Docket Item #13
BAR CASE# 2005-0171

BAR Meeting
July 27, 2005

ISSUE: Addition to rear elevation
APPLICANT: Ninette Sadusky by Rich Markus
LOCATION: 910 Pendleton Street
ZONE: RB/Residential

Figure 2 Section through side elevation

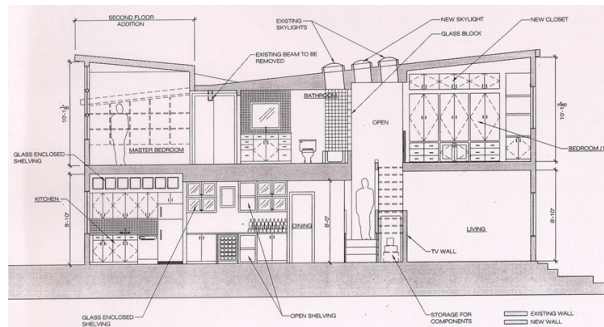
The proposal for new construction would occupy the existing footprint at grade and would add about 84 sq. ft. of new floor area at the second level. As noted above, the proposed juxtapositioning of shed roof forms of opposite pitch is accommodated by the insertion of a transitional plane or "cricket" at the new, higher mass of the second level addition, and by leaving a two foot section of the original roof plane and extending it on to the south wall eave.

Figure 3 Rear elevation

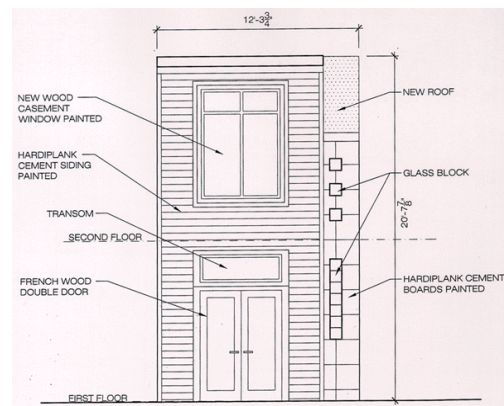
The proposed architectural treatment of the new façade is conventional, and perfectly acceptable in most respects. The major exception is the glass block/panel treatment proposed for the 2' wide section of wall below the original roof extension. This design is modest yet striking in the simplicity and crispness of the use of materials to clearly differentiate new work from old in ways seldom seen or executed in historic contexts. It is highly worthy of acceptance in this discrete location.

Therefore, Staff recommends approval of the application as submitted.
